Canopy Retention Analysis

Ladera Vineyards Winery
Minor Modification P21-00294-MOD and Viewshed P22-00109
Planning Commission Hearing June 7, 2023

Re: Ladera Vineyards Minor Modification– Response to Napa County comments on biological resources (File # P21-00294)

Figure 1. Land Cover

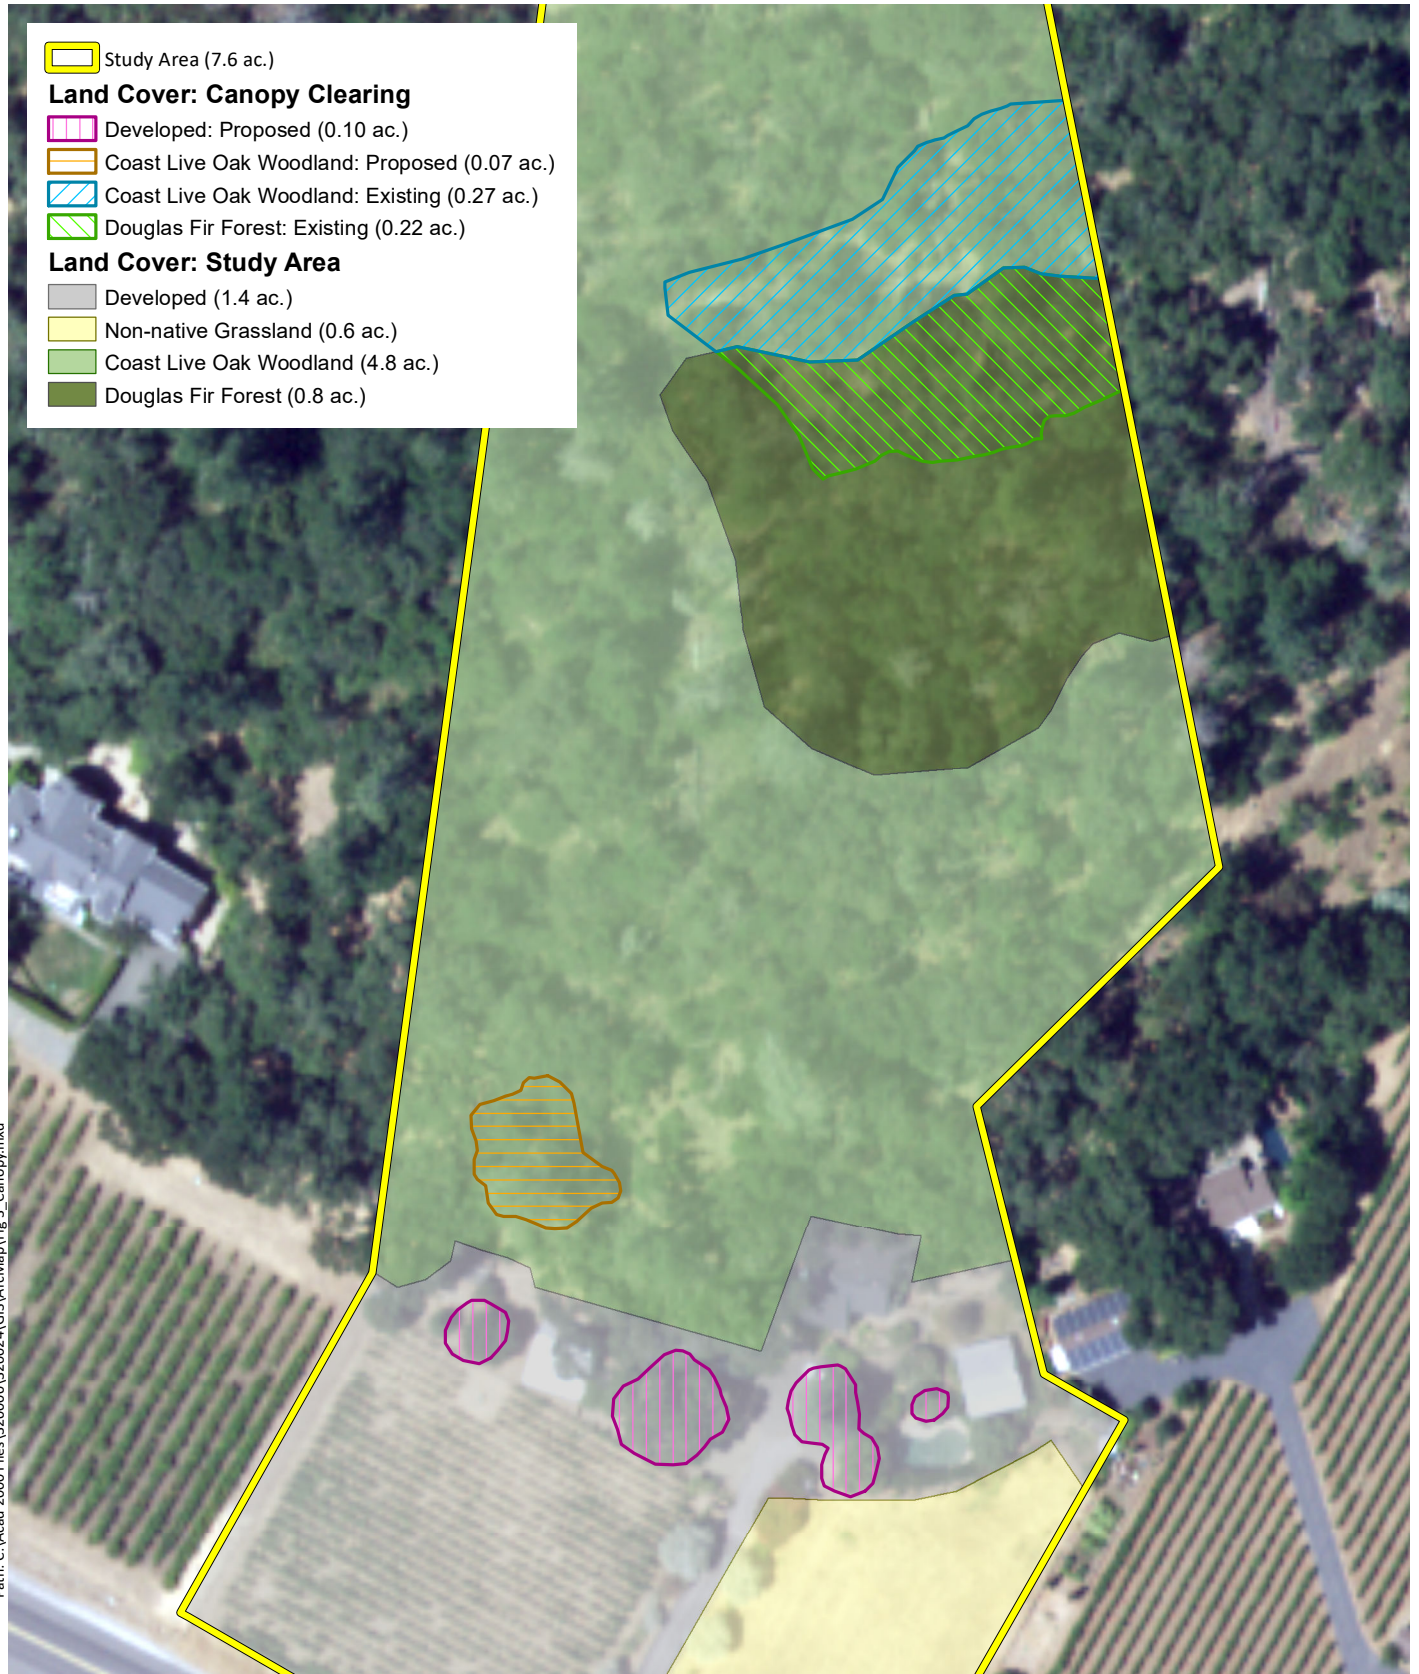
1. Pursuant to NCC Chapter 8.80.135 (Conservation regulations for fire-damaged properties and fire-damaged vineyards), the vegetation canopy cover analysis occurring on a fire-damaged property in the AW shall be based on the existing vegetation canopy cover as configured on the parcel existing on June 19, 2018. . . . Please revise accordingly. (p. 6)

For consistency, a revised land cover figure using a 2018 baseline aerial is included in Attachment A. As suggested in the full version of the County's comment, there are no notable differences in the extent of on-site canopy between the two aerials (2016 versus 2018) and thus WRA's mapping is unchanged.
